SZC. Requirements 12, CPMMP and 19, Design Approval.  
Discharge Consultation Summary Report Draft. Rev 0.2 PP 27/11/23

Req. 12 CPMMP

**Section 1 ESC**

Temporary Hard Coast Defence Feature DRW 100419 & Para 4.2

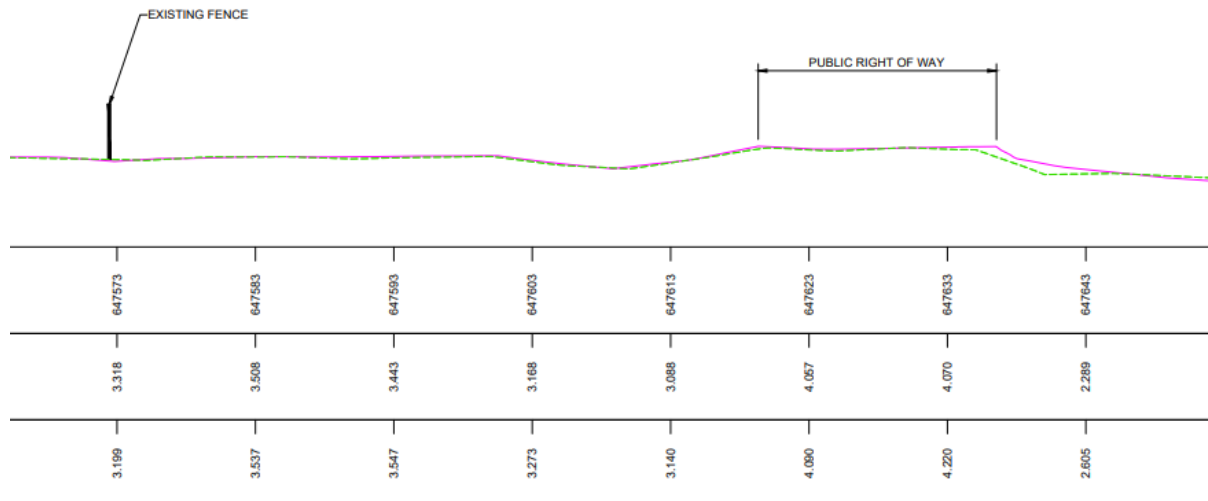
*This will obstruct the existing PRow and a temporary alternative route seaward of the sheet pile wall is proposed. SCC require clarification as to how the PRow or temporary alternative access will be kept open/managed during the installation of the temporary sea defence, particularly as construction will be from the south and affecting PRow outside of the order limits.*

ESC requires SZC Co to respond to this request.

Section @ F-F Prior to Start of Construction

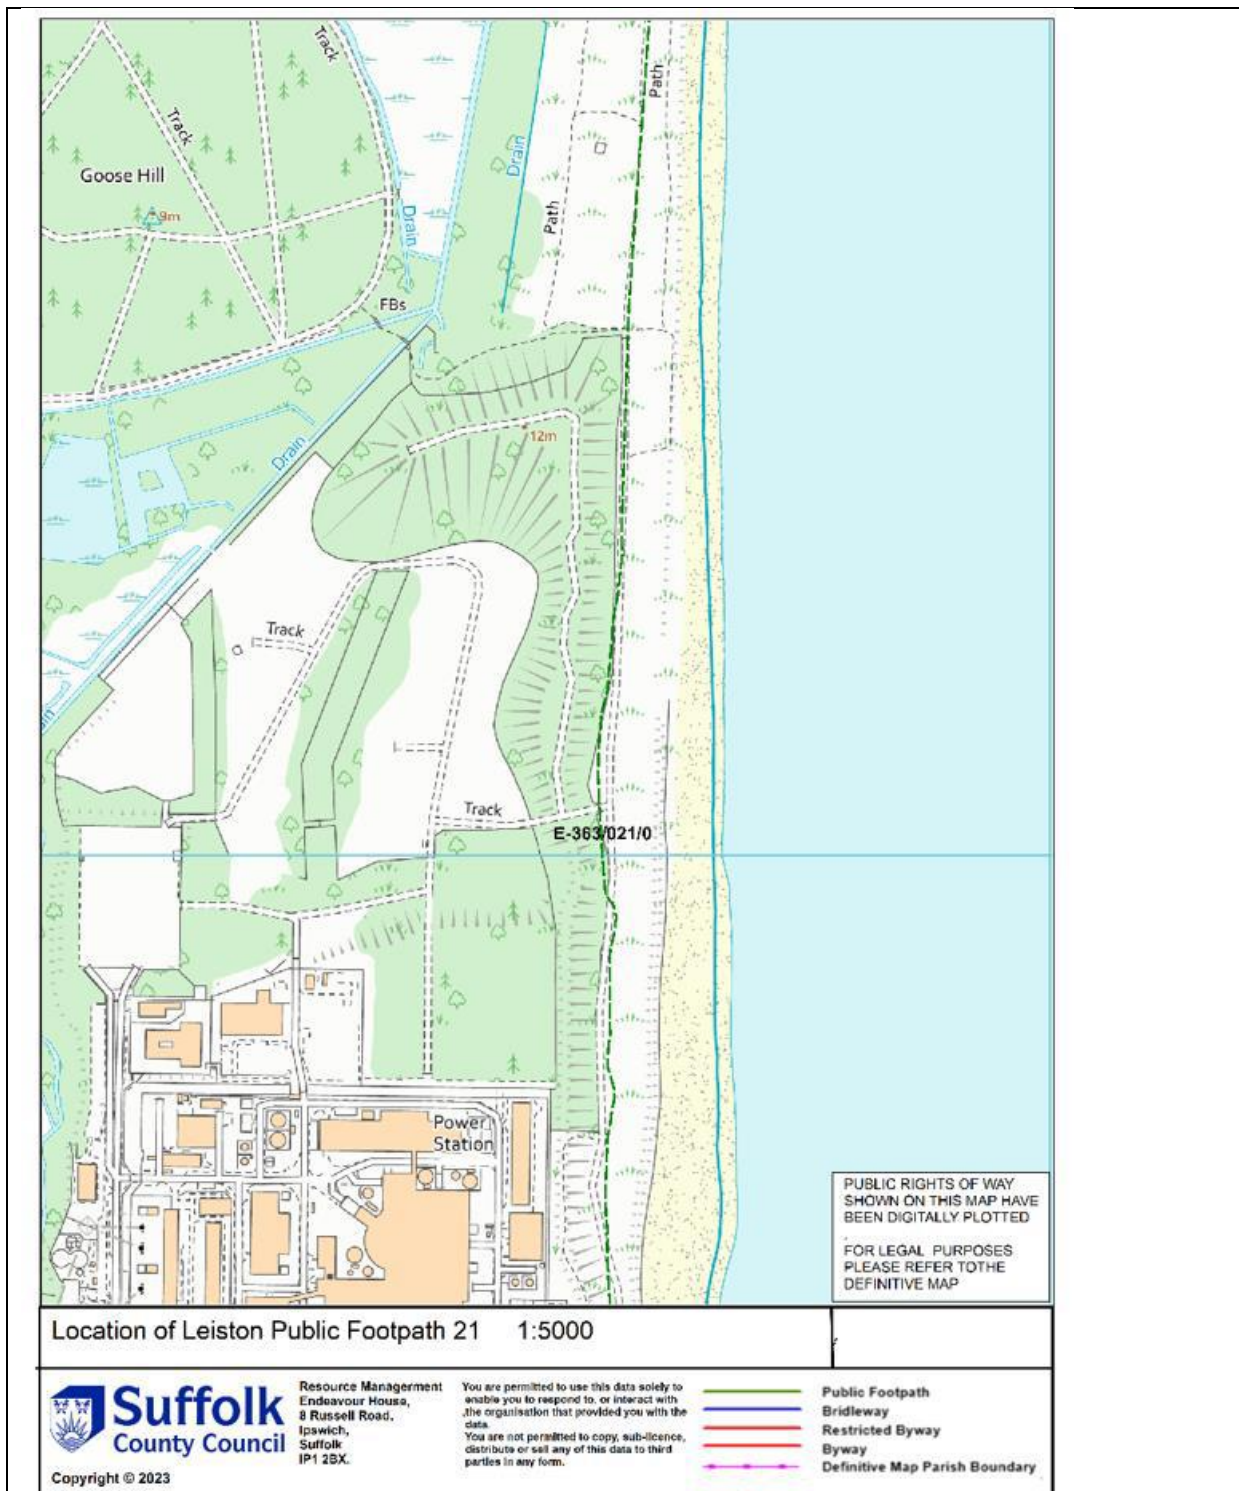
*The position of the PRoW is incorrectly marked. The PRoW is adjacent to the existing fence See extract from the Definitive Map below), not 45m to the east as shown on this drawing and therefore gives a false impression of the location of the design and should be corrected. (extract below)*

ESC requires SZC Co to respond to this request.

Figure 1: Annotated Plan Submitted at ISH 11

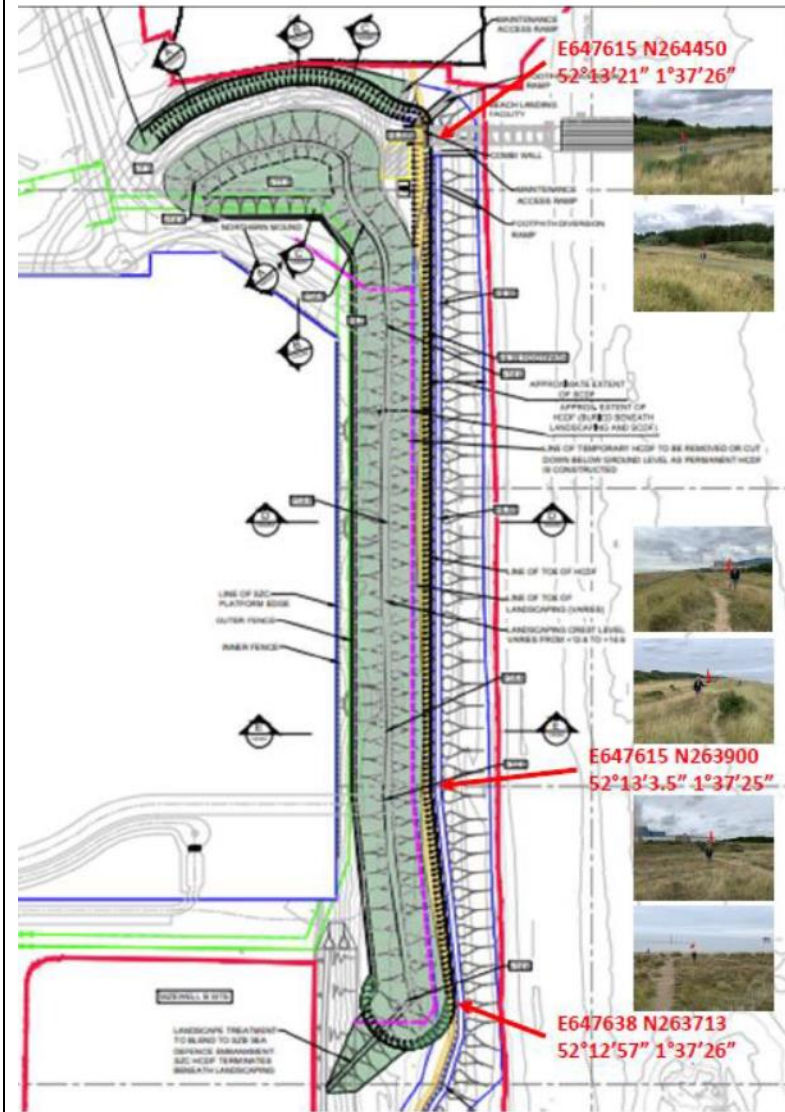
*The last plan submitted to the Planning Inspectorate's Examination of the Sizewell C Development Consent Order shows that the Hard Coastal Defence (HCDF) at its most southeastern point, the Southern Tie In Roundhead will be situated significantly east (seaward) of the existing natural embayment profile between Minsmere Sluice, north of the site, and Sizewell village to the south of the proposed Sizewell C site.*

Figure 2: General Arrangement Plan Showing Southern Tie In Roundhead and C-C Positions

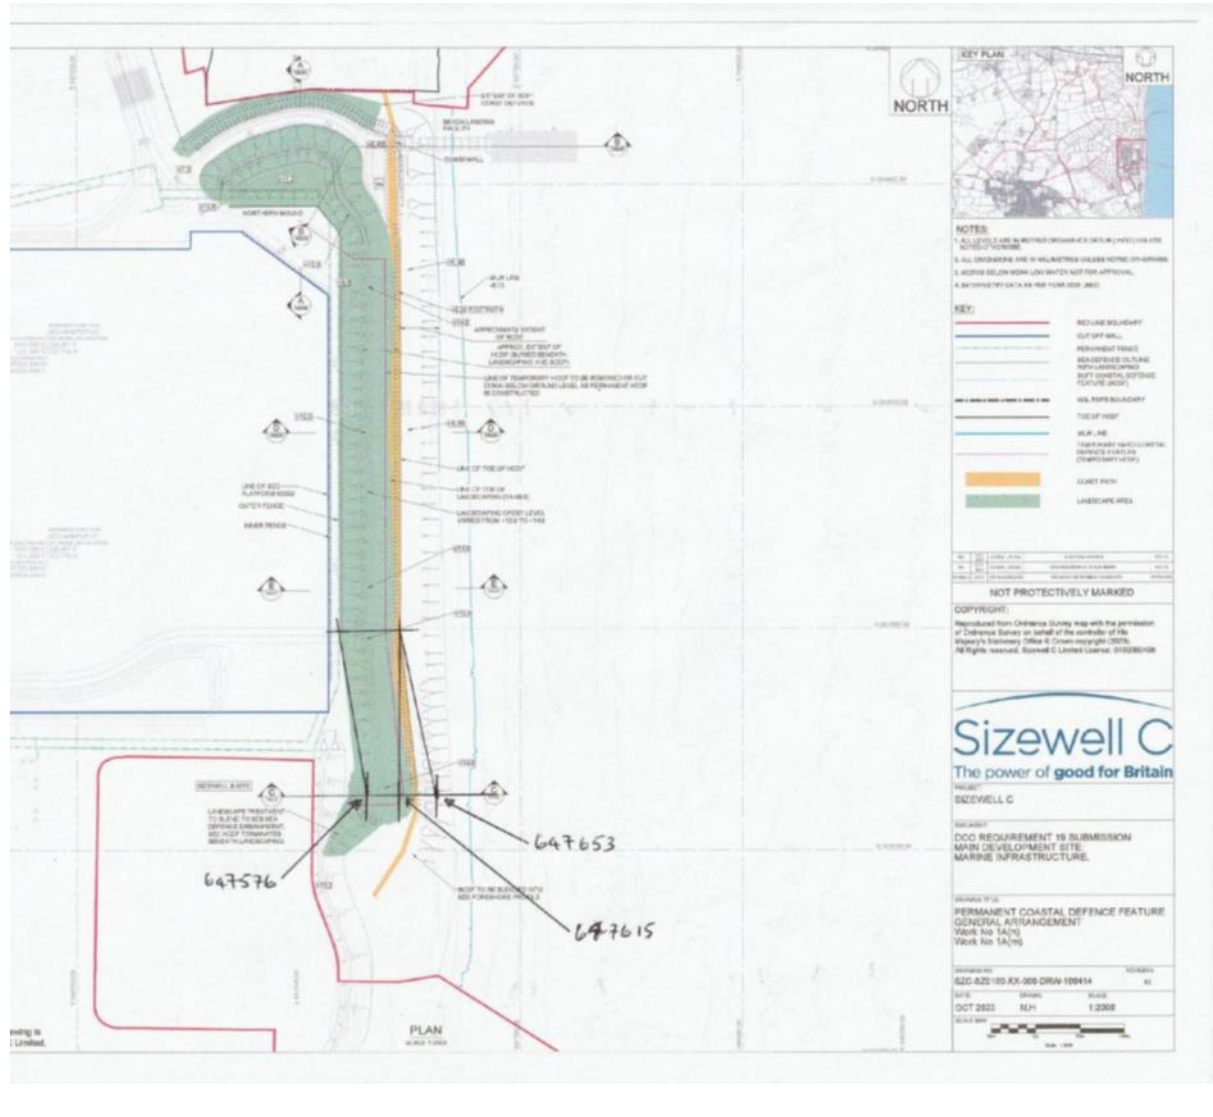
*There are clear discrepancies between the Coastal Defence Feature General Arrangement Plans and the Southern Tie In Roundhead eastings provided in the DoR 19 cross section C-C. Whilst cross-sections D-D and E-E agree with both the DCO and DoR General Arrangement Plans, the Southern Tie In cross-section at C-C, provided with DoR 19 submission, do not agree with DCO or DoR 19 General Arrangement Plans and it appears that both DCO and DoR 19 General Arrangement plans are identical apart from the indicators of the cross-sections. See Figures 1 through 4 below.*

*The General Arrangement Plans do not represent the actual easterly positions of the Hard Coastal Defence Feature toe at the Southern Tie In, which is significantly east of the existing sacrificial dune and is several metres east of the current easterly edge of the Sizewell B salient. This is apparent from both the 2019 and 2020 existing ground lines shown in section C-C (Figure 4 below).*

ESC agrees with the above observations wrt the location of the southern HCDF as defined in plans submitted with the DCO and Req.19. ESC agrees that the cross section for this feature submitted in Req. 19 drawing 417 shows it to be significantly further seaward that is shown in Req. 19 drawing 414. If the position shown in section CC on drawing 417 is a proposed design amendment by SZC Co then ESC will require further information as justification including an assessment of how this affects viability of the SCDF in this vicinity and the resilience of the HCDF foundation.

ESC has sought an explanation of this difference from SZC Co.

Figure 3: Cross Sections D-D and E-E from DoR 19

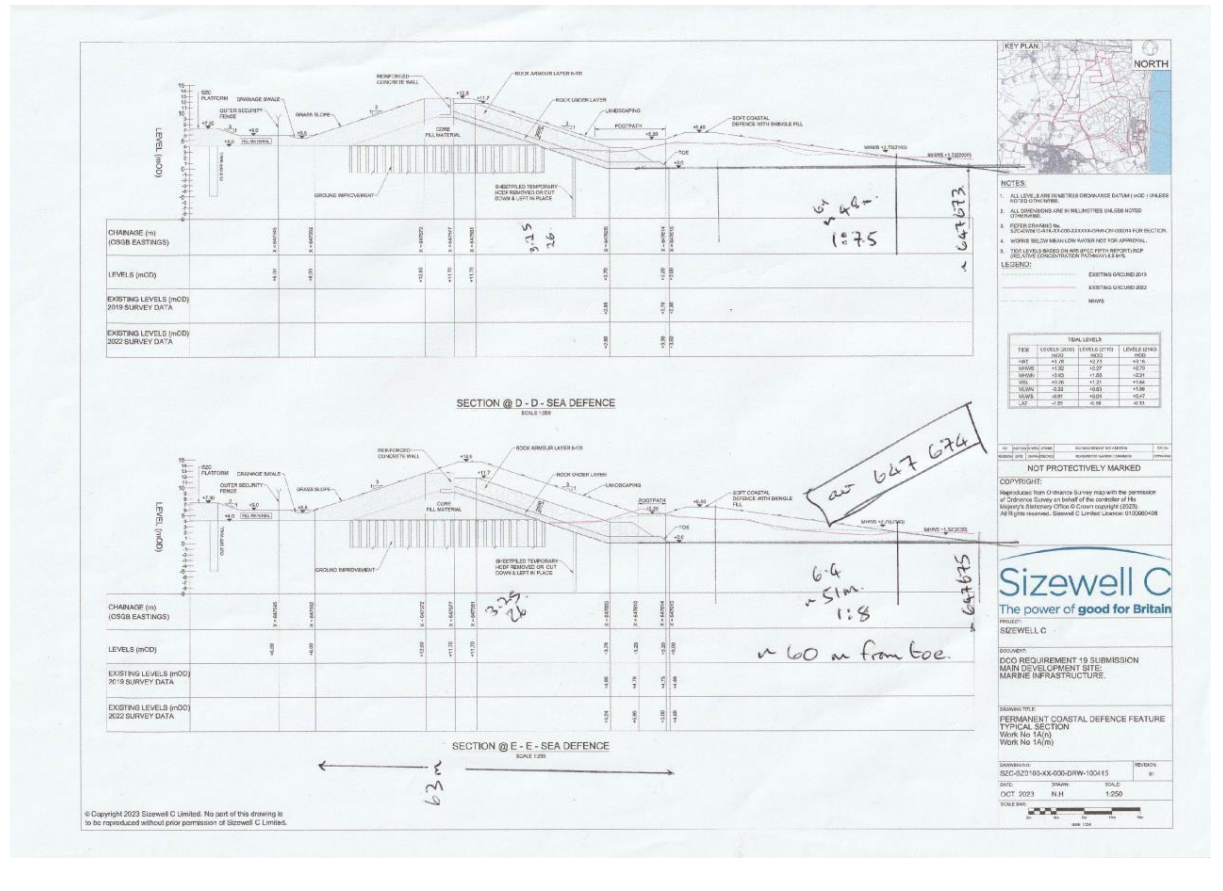
*Furthermore, from cross sections D-D and E-E (Figure 3 below) the toe of the HCDF and the path above on the SCDF sand/shingle substrate at +5.2mOD rises seaward to +6.4mOD before sloping away at about 1:8 to meet the existing beach. From the toe of the HCDF it is ~60m before 0mOD (easting 647673) would be reached, although the 2019/2020 beach level is reached at about 35m (easting 647648).*

Figure 4: Cross Sections A-A, B-B and C-C from DoR 19

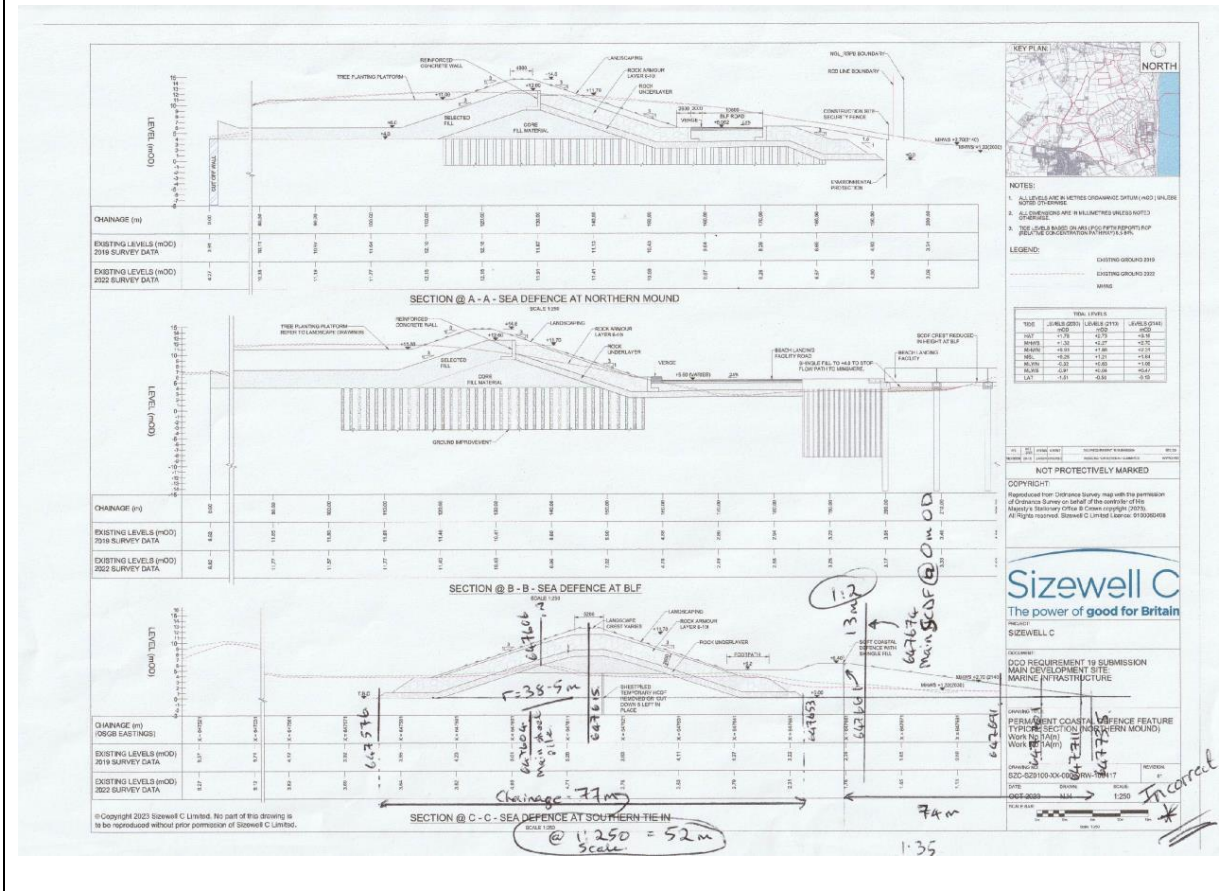
*In particular cross section C-C, of the Southern Tie In Roundhead feature, **now shows that the seaward extent of this feature has not been represented properly in any submitted General Arrangement Plan views going back to the DCO examination submissions or in these latest submissions.***

*It is difficult to see how a stable slope can be formed at C-C unless the seaward extent of the HCDF/SCDF design protrudes significantly further than indicated on the General Arrangement plans, especially after accounting for the discrepancies mentioned above.*

*Apologies – again – there seems to be an error on how the chainages / profiles have been pulled across from CAD into the section drawings. Therefore, there is an error in the chainages given in drawing 417. In plan, drawing 414, everything is correct.*

*We will re-issue the erroneous drawing 417 as a matter of urgency.*

*11.3 • Drawing Ref: SZC-SZ0100-XX-000-DRW-100417 shows Northern Mound with indication that land levels are anticipated to change on RSPB land. There appears to be no key to the specific*

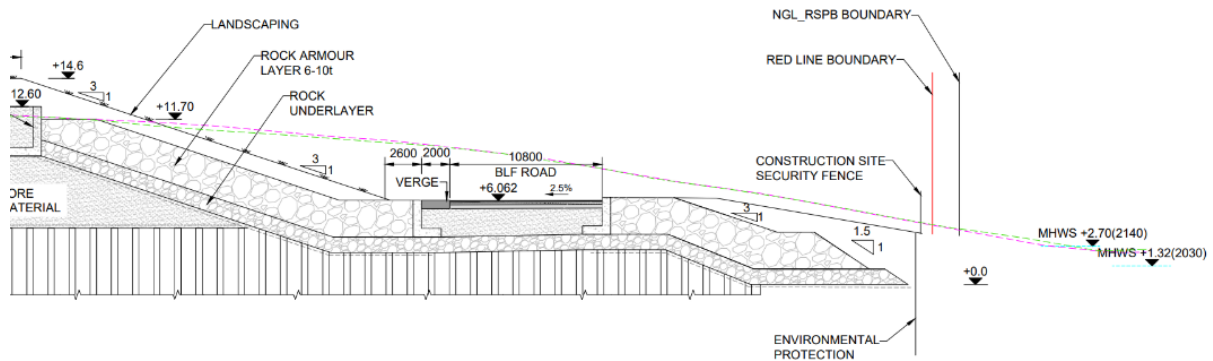
drawing, but elsewhere it is suggested that the green line represents current land level and the pink line represents post construction land level. The drawing shows the land level (pink line) on the RSPB land as lower post construction, but this is confusing as the design detail appears to show a different land level that terminates at the security fence with no indication of how this ground level keys into the DCO red line boundary and RSPB boundary.
